Re: Application for Amendment to Form of Transmission Connection Agreement – McLean’s Mountain Wind Limited Partnership

**APPLICATION FOR LEAVE TO AMEND A TERM IN THE CONNECTION
AGREEMENT BETWEEN MCLEAN'S MOUNTAIN WIND LIMITED PARTNERSHIP
AND HYDRO ONE NETWORKS INC.**

10. The Applicant hereby applies to the Board for approval to amend Section 1.2.1 of Schedule E to the Connection Agreement by deleting the existing provision and substituting for it the following section 1.2.1:

**COPY OF REGISTERED PLAN 31R-3942 SHOWING
DISCONNECT SWITCHES AND MSOs**

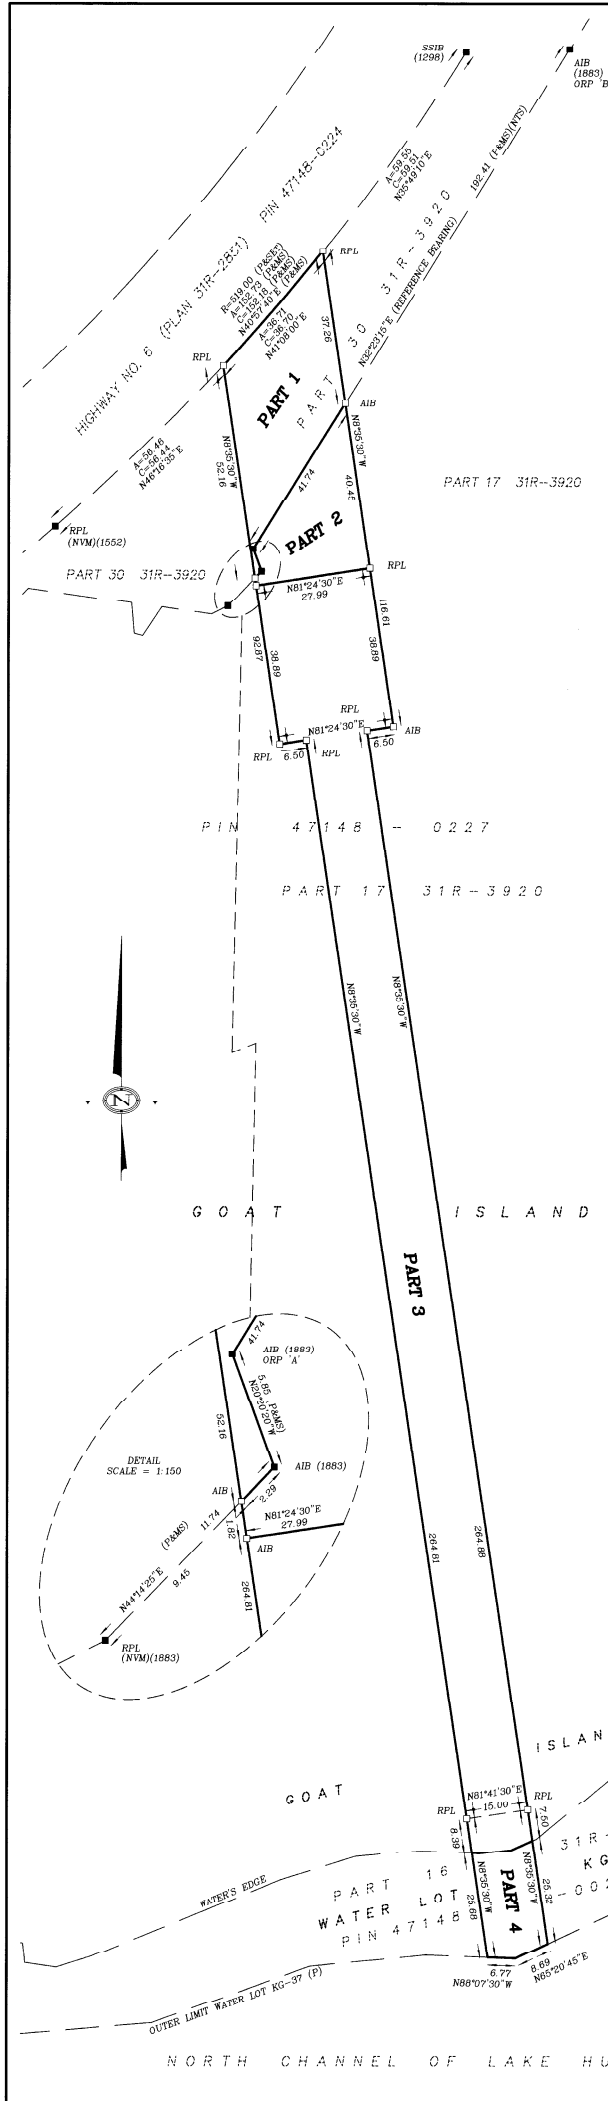
13. As noted in the Application, the Applicant will be installing an isolating disconnect switch. This can be seen in the single line diagram of the proposed connection at Exhibit B, Tab 1, Schedule 1, and it has been shown in the markup of Registered Plan 31R-3942 showing disconnect switches and MSOs at Exhibit B, Tab 1, Schedule 3 (a copy of the Plan without disconnect switches and MSOs can be found at Exhibit B, Tab 1, Schedule 2). However, with the amendment proposed in the Application, the MSOs, and not the disconnect switches, will be located at the point of interconnection.

14. This Application is being made because Hydro One does not currently have its own independent right to access the lands on which the isolating disconnect switch will be located (as part of the Applicant's switching station), but it does have full access to the lands under which the MSOs will be located. In the markup of Registered Plan 31R-3942 showing disconnect switches and MSOs (Exhibit B, Tab 1, Schedule 3), Hydro One has easement rights over Part 1 on the Plan, and the MSOs are to be located on that part. The Applicant has easement rights over Parts 2, 3 and 4 on the Plan, and the disconnect switches are to be located in the vicinity of the boundary between Parts 2 and 3.

- 1.2.1. The Customer shall provide a mid span opener (MSO) at the point or junction between the Transmitter and the Customer, i.e., at the point of the interconnection, which physically and visually opens the main current-carrying path and isolates the Customer's facility from the transmission system.
